適航指令發布單

民航局 AD 編號 AD number	CAA-2019-10-006	發布日期 Date issued	2019/10/16
適用之航空產品 Applied to (models, serial numbers or part numbers, as applicable)	This AD applies to all The Boeing Company Model 787-8, 787-9, and 787-10 airplanes, certificated in any category.		
主旨摘要	This AD requires repetitive operational checks of the leading edge outboard slats and applicable on-condition actions, and also requires revising (AFM) to prohibit flap retraction under icing conditions and revising the existing maintenance or inspection program, as applicable, to incorporate a new operation check.		
民航局 CAA <input type="checkbox"/> 本國產品 Native products <input type="checkbox"/> 其他個案 Other	設計國民航主管機構 Original Authorities <input checked="" type="checkbox"/> FAA <input type="checkbox"/> EASA <input type="checkbox"/> Brazil <input type="checkbox"/> Transport Canada Civil Aviation <input type="checkbox"/> DGAC <input type="checkbox"/> Germany LBA <input type="checkbox"/> CAA-NL <input type="checkbox"/> UK CAA <input type="checkbox"/> Japan CAB <input type="checkbox"/> CAA of Israel <input type="checkbox"/> Other _____

[Docket No. FAA-2019-0715; Product Identifier 2019-NM-151-AD; Amendment 39-19760; AD 2019

Figure 2 (Sheet 1 of 3) Slat and Flap Inspection

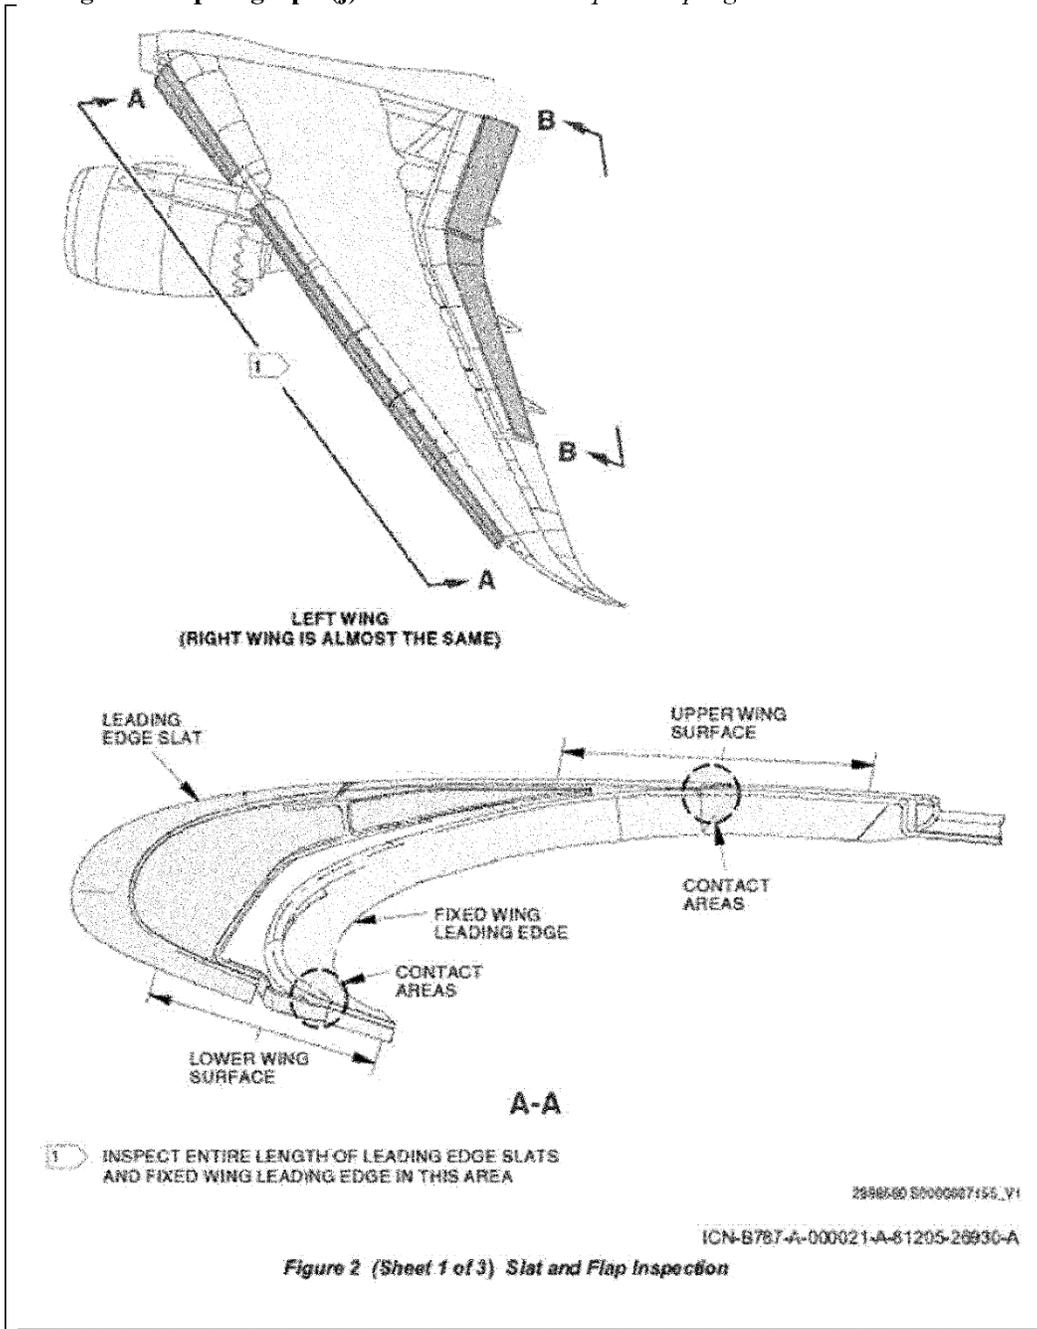
Within 60 days after the effective date of this AD, revise the existing maintenance or inspection program, as applicable, to incorporate the information specified in figure 2 to paragraph (j) of this AD. This may be done by inserting a copy of figure 2 to paragraph (j) of this AD into the existing maintenance or inspection program.

After any landing in icing conditions, do this inspection with the slats/flaps (flaps 25 detent) fully extended (Figure 2):

- (a) Examine these areas for contaminants (ice, snow, slush):

- 1) Slats/flaps surfaces
- 2) Leading edge contact surfaces

- 3) Slat actuation areas, including exposed areas of the slat track cavity, and slat cove
- 4) Flap tracks, hinges, seals

- (b) Remove the contamination that you find.

Figure 2 (Sheet 2 of 3) Slat and Flap Inspection

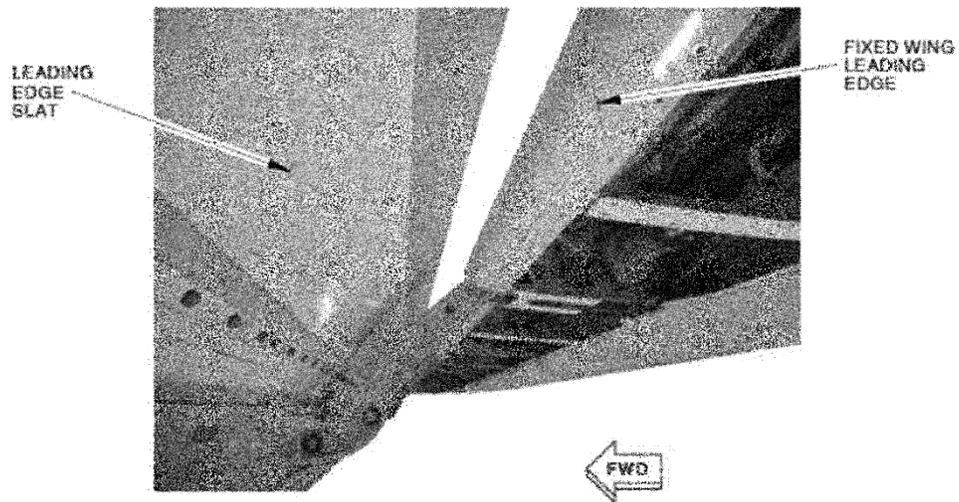
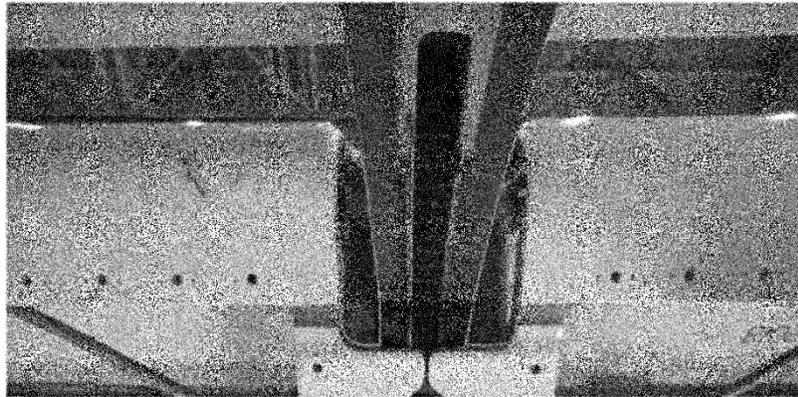
**ACTUATION AREAS
(TYPICAL)
A-A**

**SLAT TRACK CAVITY
(TYPICAL)
(VIEW IN THE AFT DIRECTION)
A-A**
